**REMARKS**

**ENTRY OF AMENDMENT UNDER 37 C.F.R. § 1.116**

**ITEM 2: OBJECTION TO THE DRAWINGS**

FIG. 3A (BACKGROUND)

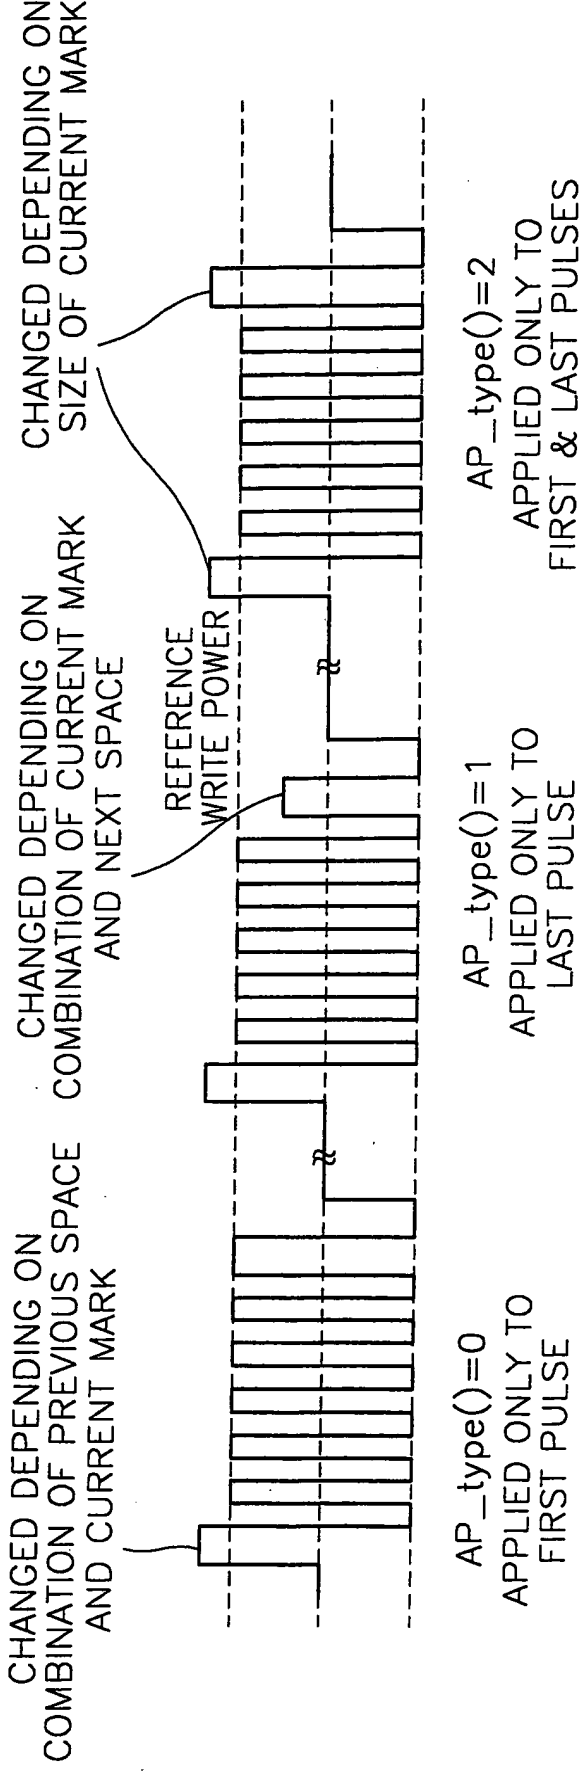
Item 2 of the Action objects to the drawings. The Examiner contends that figures 3A and 3B should be designated by a legend such as -- PRIOR ART -- since only that which is old is illustrated

Applicant points out that FIG. 3A discusses:

a first multiple pulse train, the power level of a first pulse is adjusted according to a combination of a previous space and a current mark. In a second multiple pulse train, the power level of a last pulse is adjusted depending on a correlation between a current mark and a next space. In a third multiple pulse train, the power levels of first and last pulses are adjusted depending on the size of a current mark regardless of a correlation between a mark and a space.

As seen from a comparison of FIG. 3A and FIG. 6, FIG. 3A does not discuss the method recited by claim 1 "forming a mark using a multiple pulse train comprising a first pulse, a multi-pulse having a peak power level, and a last pulse; adapting a power level of the first pulse relative to the peak power level of the multi-pulse depending on a correlation between the mark and a previous space; adapting a power level of the last pulse relative to the peak power level of the multi-pulse depending on a correlation between the mark and a next space."

In light of this objection, replacement figures are submitted herewith as suggested by the Examiner. FIGS. 3A and 3B are labeled "BACKGROUND" and replace previous FIGS. 3A and 3B. Approval of these changes to the drawings and withdrawal of the objection is requested.

Item 2 of the outstanding Office Action objects to the drawings. In light of these objections, replacement figures are submitted herewith. FIGS. 3A and 3B are labeled "BACKGROUND" and replace previous FIGS. 3A and 3B. Approval of these changes to the drawings is respectfully requested.
